# CITY OF ALBUQUERQUE

DZP.  
1003815

**Re: Office/Warehouse Development, 9550 San Mateo Blvd NE, Grading and Drainage Plan**

**Engineer's Stamp date 8-19-09 (B18/D016)**

GRADING AND DRAINAGE PLAN			
Date:	8/19/09	Revision:	
Drawn By:	RR	Date:	
Chk By:	FCA	Job No.:	1666
			<b>CG-101</b>
			SH. OF

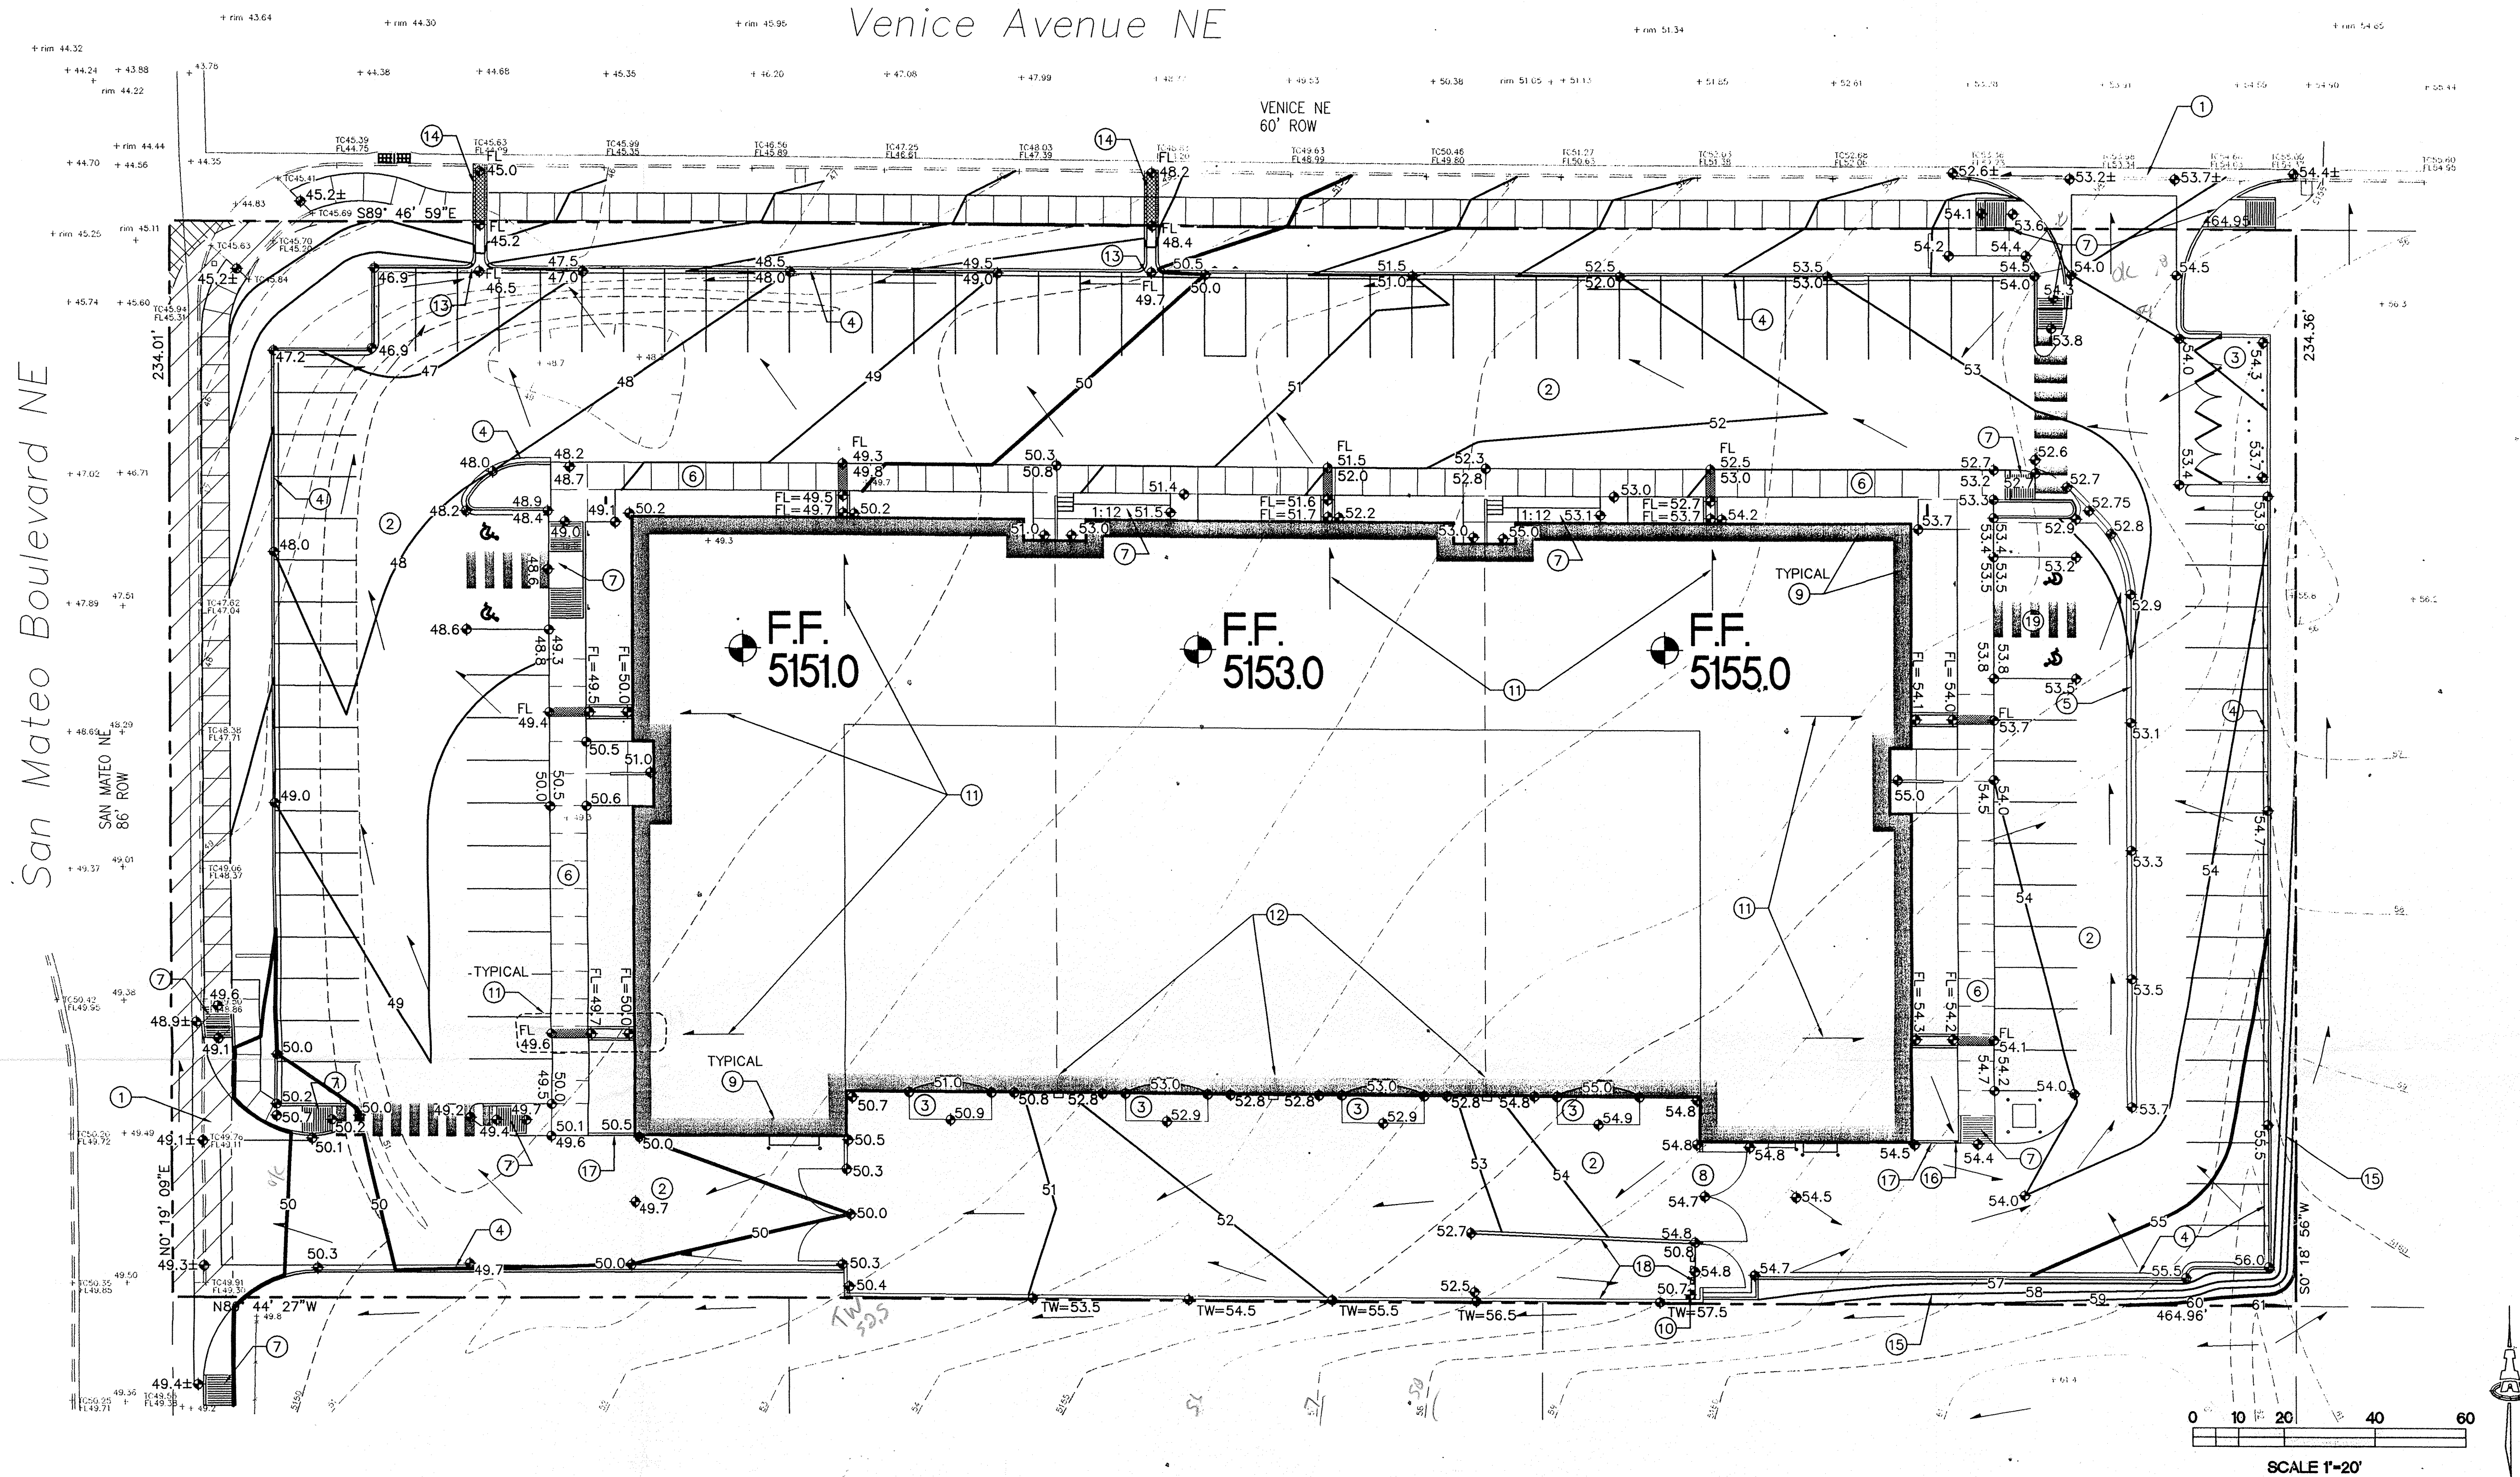
Include the TW elevation on the west end of the wall on the south side of the site on the Certification.
